SUBJECT: COMANCHE PEAK NUCLEAR POWER PLANT, UNITS 3 AND 4
DOCKET NUMBERS 52-034 AND 52-035
RESPONSES TO REQUESTS FOR ADDITIONAL INFORMATION
NO. 3105, 3327 (PARTIAL), AND 3451

Response to Request for Additional Information No. 3105 (CP RAI #76)

Response to Request for Additional Information No. 3327 (CP RAI #78)

Figure A4-6 – Pre-selected Radiological Sampling and Monitoring Points

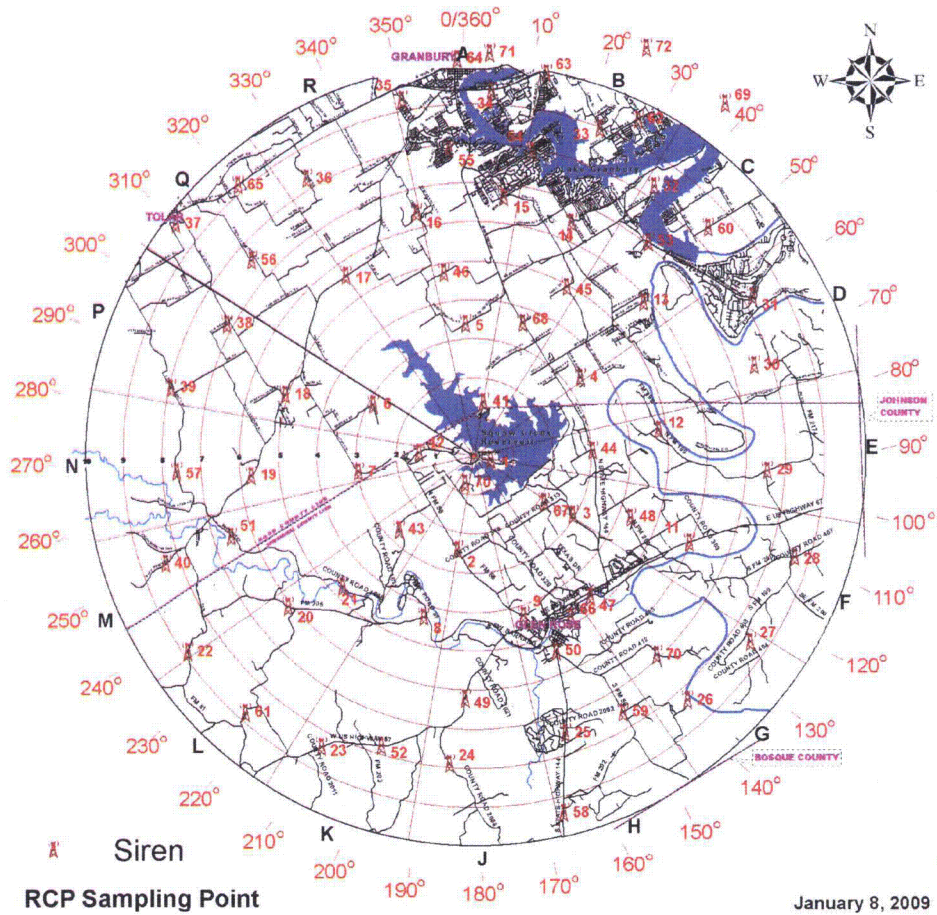
- J-3. Section J.10, "Protective Measures Implementation," (page II-64) states that emergency plan procedures (EPPs) provide locations of pre-selected radiological sampling and monitoring points. Provide a map that shows the pre-selected sampling and monitoring points. Include this information in the Emergency Plan.

-3. Comanche Peak utilizes the existing siren locations as its pre-selected radiological sampling and monitoring points in the event of an emergency at Units 1 or 2. The same locations would be utilized in the event of an emergency at Units 3 or 4. Subsection II.J.10.a of the Emergency Plan has been revised to indicate that a map illustrating pre-selected radiological sampling and monitoring points has been included in Appendix 4.

- Figure A4-1 illustrates the Plume Exposure Pathway EPZ, including the permanent resident population of each emergency response planning area.
- Figure A4-2 illustrates the permanent resident population of the Plume Exposure Pathway EPZ in a sector format
- Figure A4-3 illustrates the locations of reception centers assumed for conduct of the ETE.
- Figure A4-4 illustrates the evacuation routes for the Plume Exposure Pathway EPZ population in Somervell County.
- Figure A4-5 illustrates the evacuation routes for the Plume Exposure Pathway EPZ population in Hood County
- Figure A4-6 illustrates the pre-selected radiological sampling and monitoring points.
